Job No. MA24-03
Kahului SBH Prefabricated Bathroom & Wastewater System
Site Plan (Not to Scale)
REVISED per Addendum No. 4 dated April 11, 2024

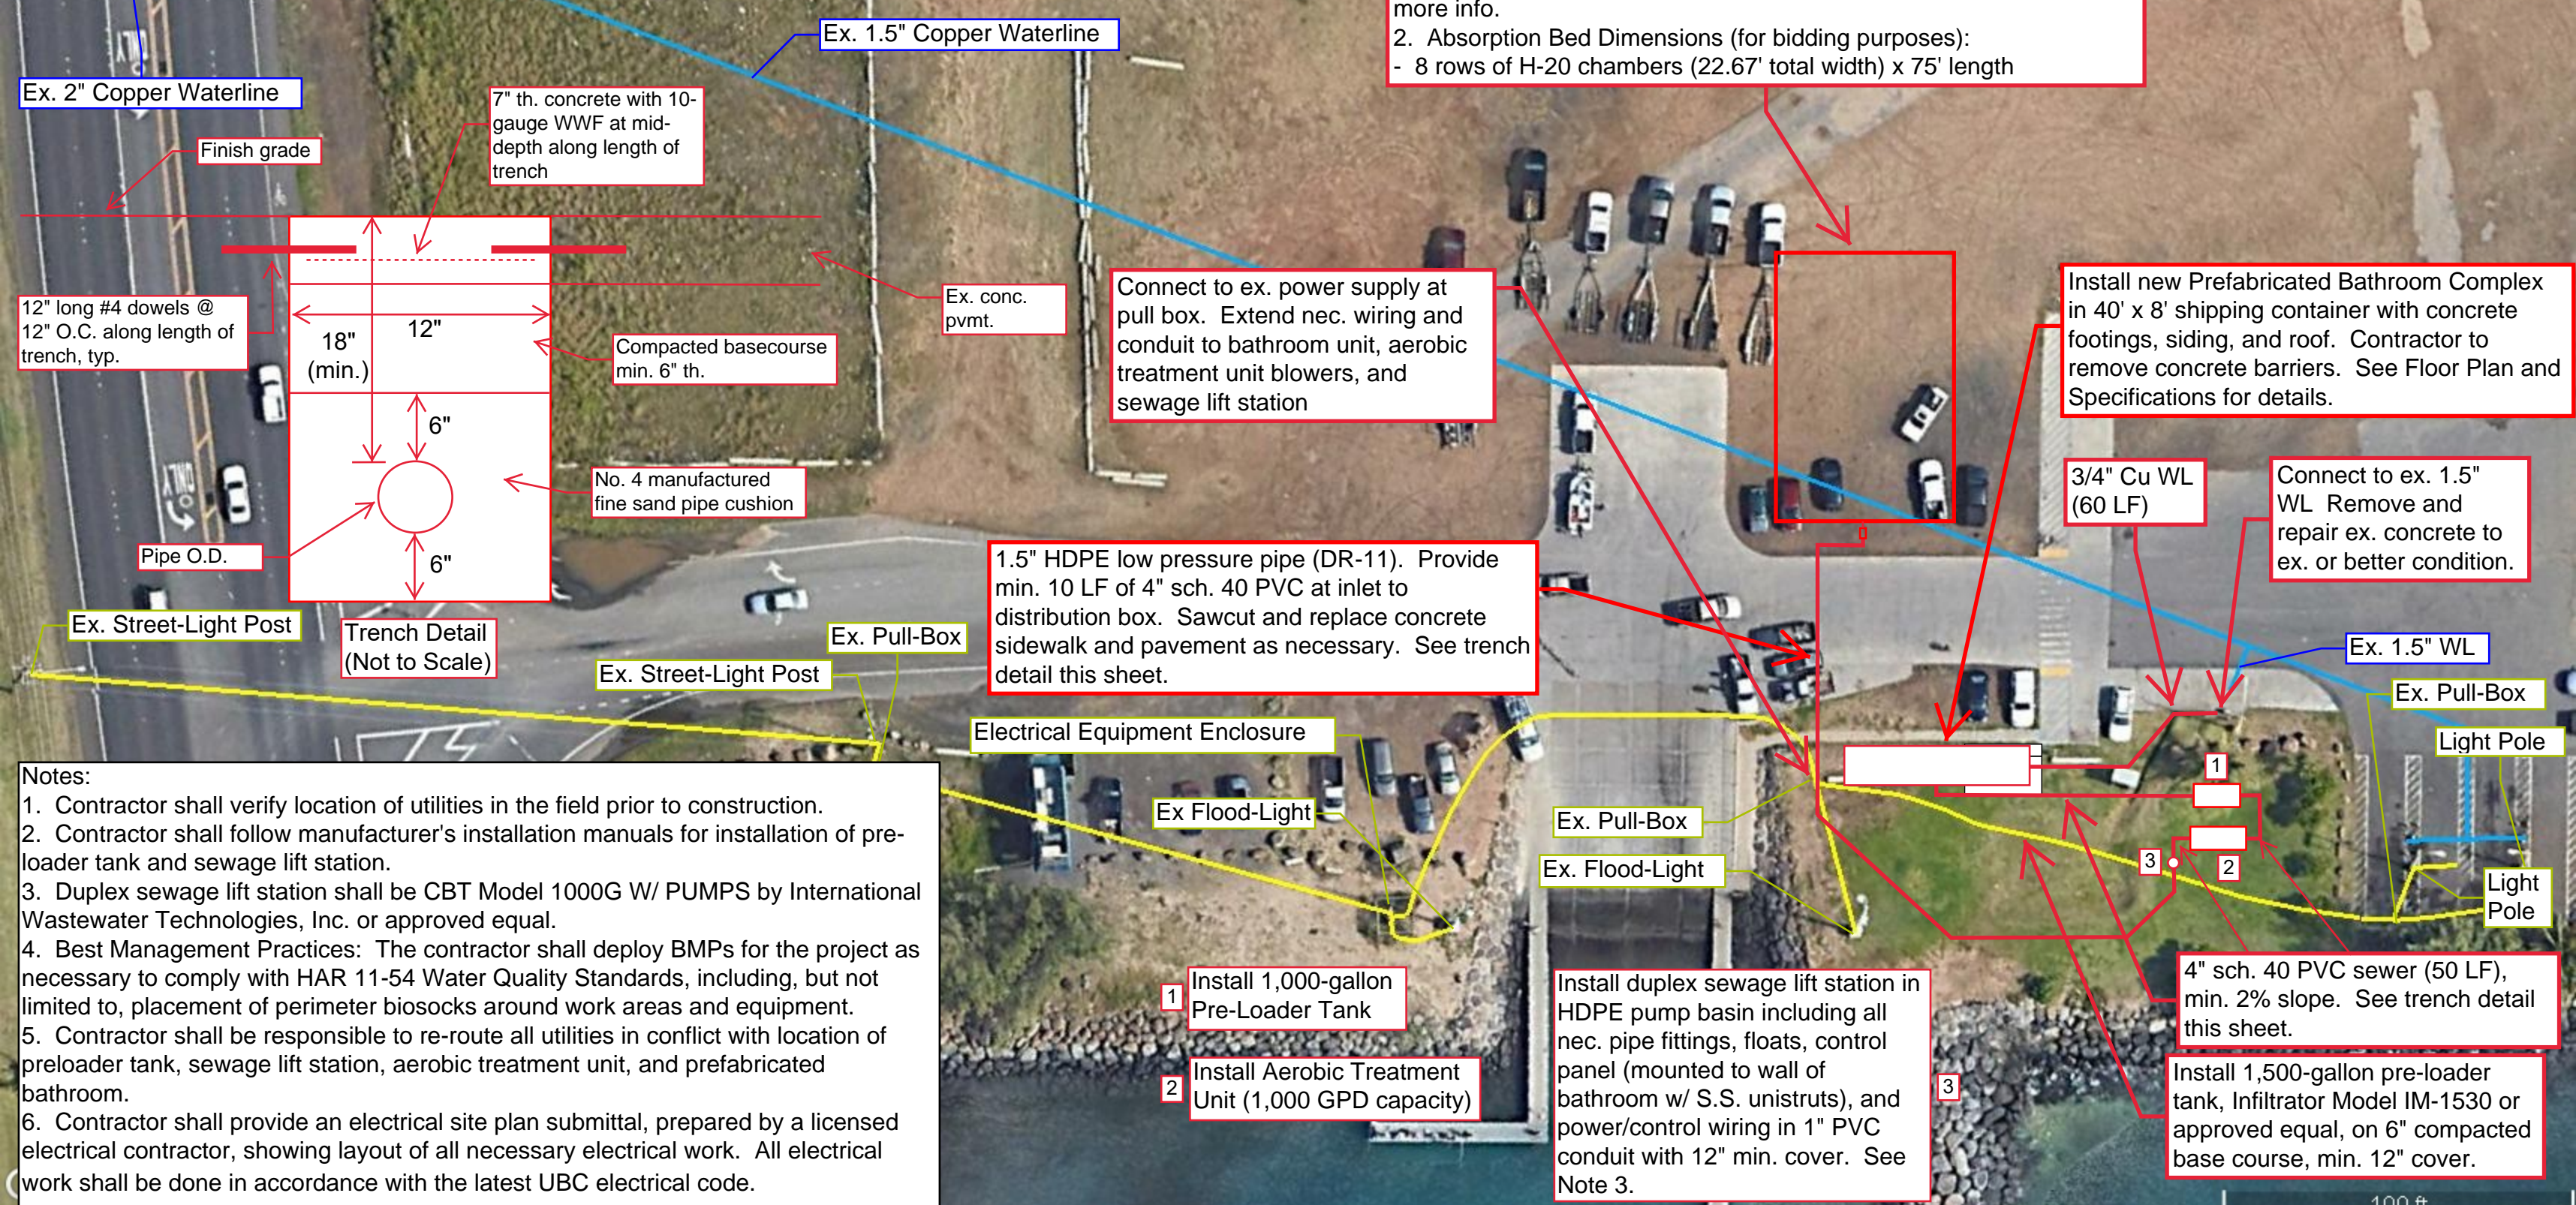
1 Install 1,000-gallon Pre-Loader Tank

2 Install Aerobic Treatment Unit (1,000 GPD capacity)

Install duplex sewage lift station in HDPE pump basin including all nec. pipe fittings, floats, control panel (mounted to wall of bathroom w/ S.S. unistruts), and power/control wiring in 1" PVC conduit with 12" min. cover. See Note 3.

Install 1,500-gallon pre-loader tank, Infiltrator Model IM-1530 or approved equal, on 6" compacted base course, min. 12" cover.
